WATER QUALITY MEMORANDUM

Utah Coal Regulatory Program

RE: Third Quarter of 2014 Water Monitoring, PacifiCorp, Trail Mountain Mine, C/015/0009, Task ID #4679

Figure 1. The head in TM-1B slowly began rising in early 2003. Although highly variable from quarter to quarter, the four year mean water level has begun to rise again after the slight dip in late 2012.

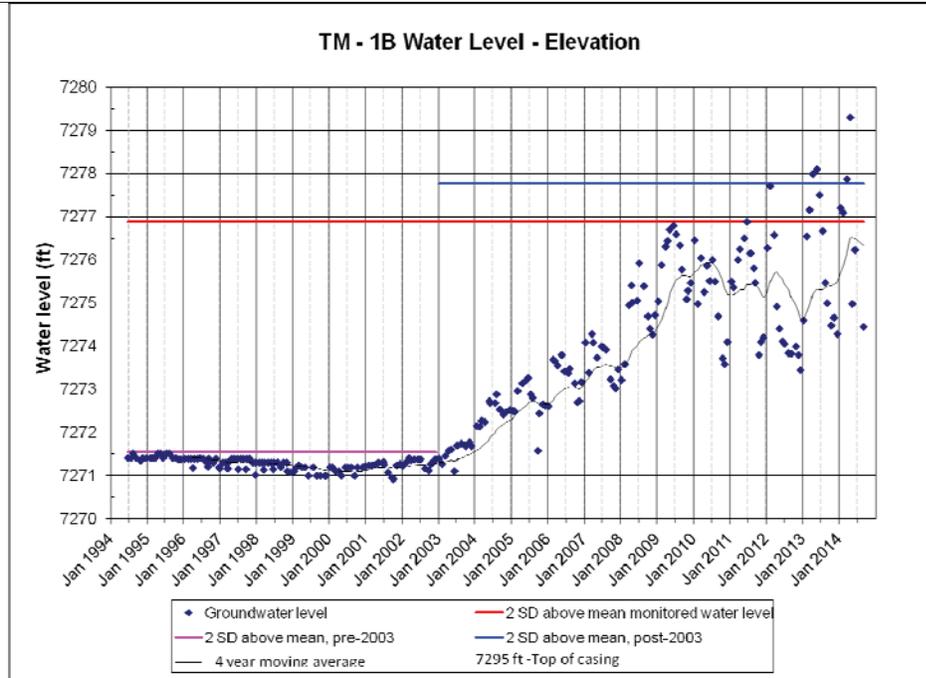
TM-1B is monitored for water level monthly and for operational parameters quarterly (Figure 1). Since July 2004, the water level in TM-3 has been reported as piezometric head above the well casing by measuring the pressure on top of the sealed wellhead with a gauge (Figure 2). CCCW – 1A, CCCW –

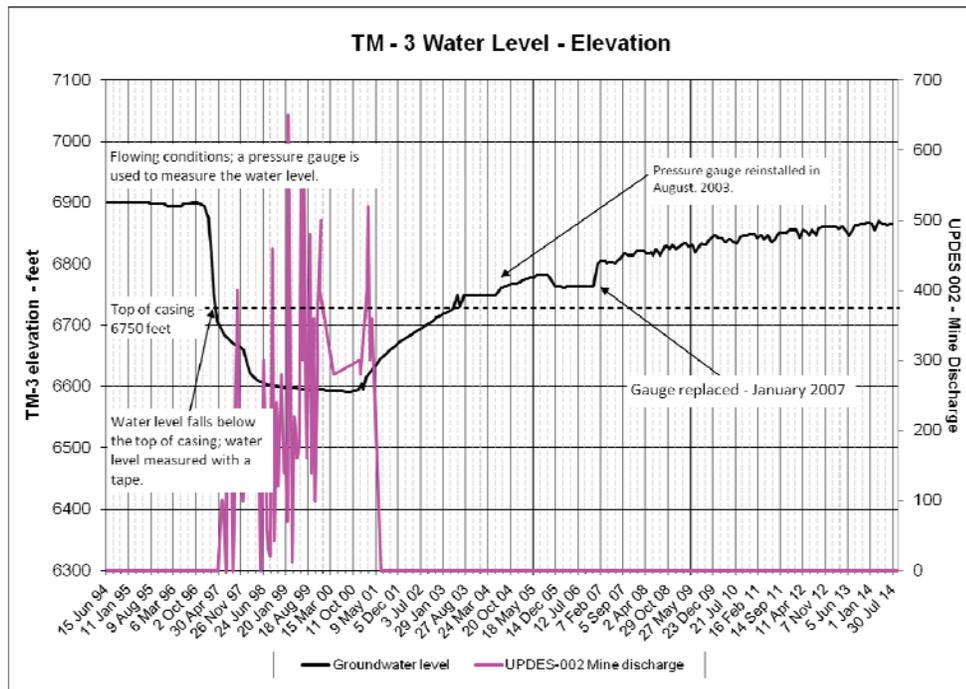
Figure 2. TM-3 water elevation peaked in June 2005, remained steady through October, dropped 18.5 ft in November and December 2005 and remained virtually unchanged during 2006. The pressure gauge was replaced in January 2007 and values jumped to approximately match the pre-2006 curve. During the first half of 2007 the curve was relatively flat, but it has been steadily climbing. The outgoing document Reduce Hydrologic Monitoring Sites, PacifiCorp, Deer Creek, C/015/0018, Task ID #4332 stipulates this well should not be released until 6,900 ft is reached.

Figure 3. Water levels in Cottonwood Canyon Creek monitoring wells.

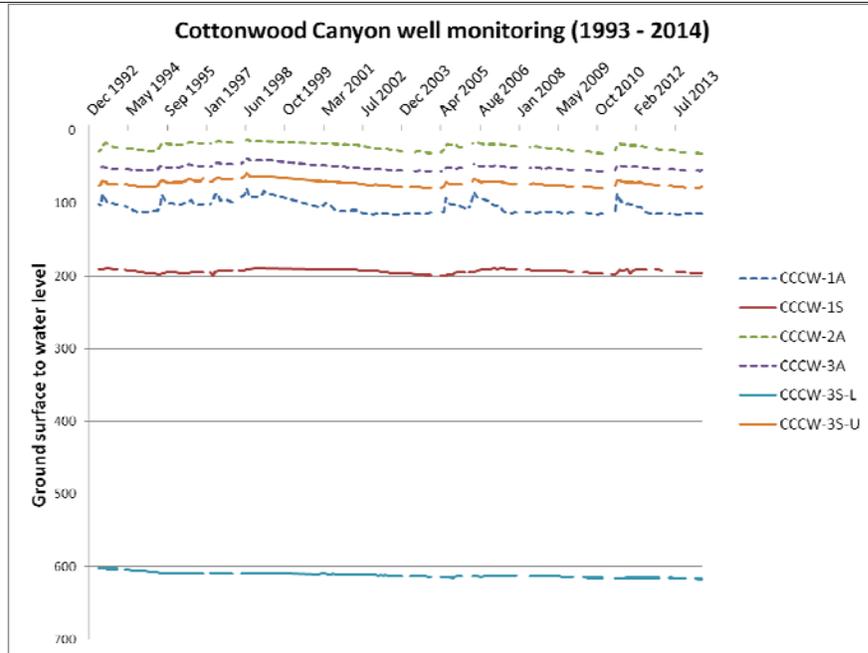
1S, CCCW – 2A, CCCW – 3A, CCCW – 3U, CCCW – 3L are monitored for water level only (Figure 3).
